SERVICE BULLETIN SB99.9B

Machines/Models: LX31,41,50 European with Outriggers
Serial Numbers: 1000-2746

PURPOSE: To enhance operation of limit switch during outrigger operation.

OPERATION REQUIRED: Replace existing white proximity switches with roller type.

Figure 1

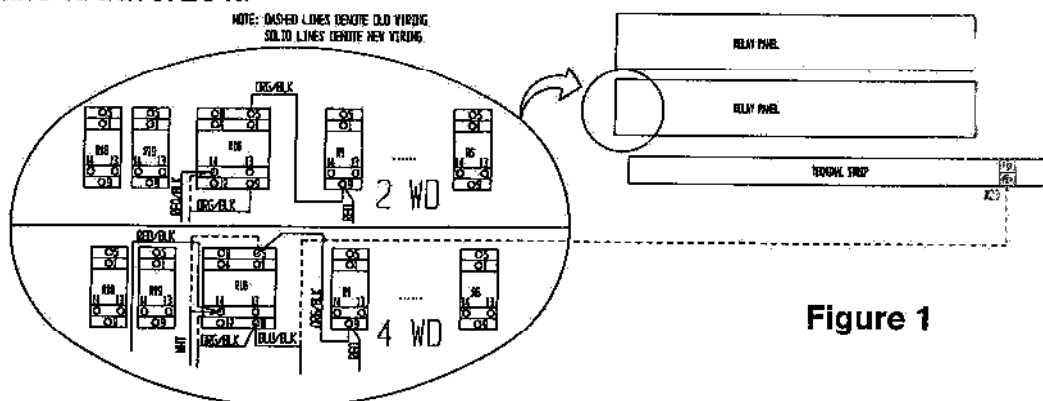
- D. Move the blue/black wire from Terminal Strip #23 to Terminal #9 of R16. See Figure 1.
- E. Disconnect the white wire from R16 Terminal #5. Cut to fit and connect to Terminal #14 of R16.
- F. Move the orange/black wire from R16 Terminal #14 to R16 Terminal #9. Leave the red/black wires on Terminal #14.
- G. Add an orange/black jumper from R1 Terminal #9 to R16 Terminal #5. Leave the red wire on Terminal #9 of R1.
- H. Adjust Roller Switch Dual (066490-001) so machine goes into "creep speed" before platform height reaches 9 ft. Tested "creep speed" should be 18-22 sec. for machine to travel 20 ft.

Figure 3

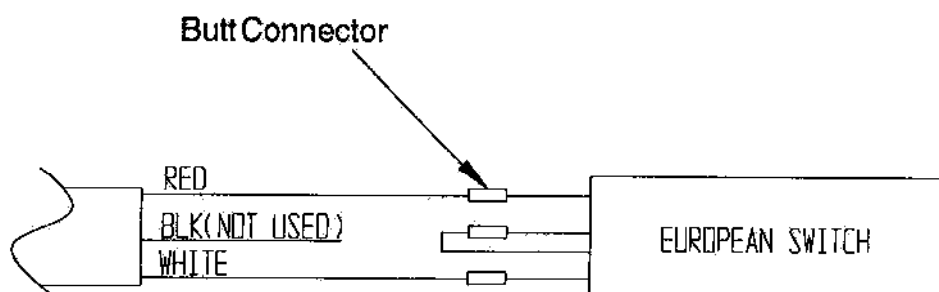
4. Cut off 3 Conductor Cable from switches. Tie back black wire. It will no longer be used. See Figure 3.
5. Attach Roller Switch Dual (#066490-001) and Platform Down Bracket (#067473-000) as shown in Figure 2.

6. The new switch has four black wires coming off the back. Connect the two middle wires together. Butt connect red wire, from the 3 Conductor cable, to one of the black wires. Connect the white wire, from the 3 Conductor cable, to the remaining black wire of switch. See Figure 3.

Figure 4

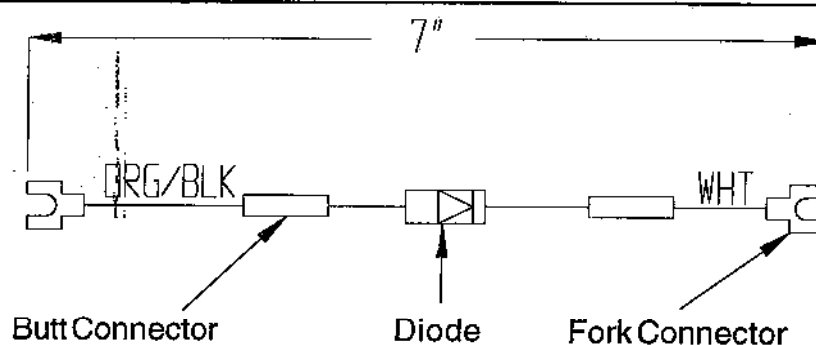
8. Assemble the Diode Assembly shown in Figure 4 using supplied parts. Insulate Diode leads with sleaving. The total length of Diode Assembly should be 7 inches.
9. Locate R28 (Lower Control Box Assembly) and connect orange/black end of Diode to Terminal #9. Leave all existing wires on R28. See Figure 5.
10. Connect white end of Diode Assembly to Terminal #14 of R15. See Figure 5.
11. Secure all modifications with supplied cable ties.

Figure 5

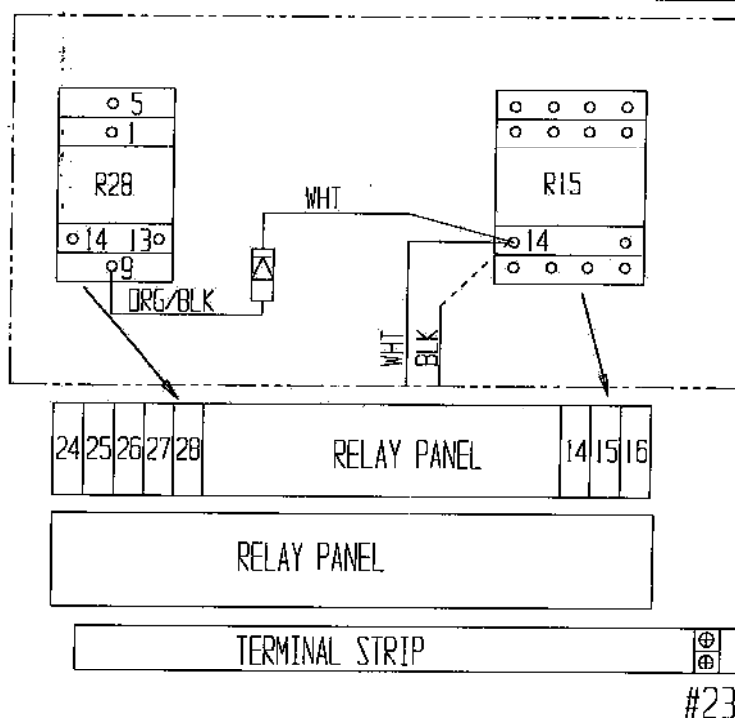
7. Locate R15 (Lower Control Box Assembly) and disconnect black wire from Terminal #14. Leave white wire connected. Insulate black wire and tie it back out of the way. See Figure 5.
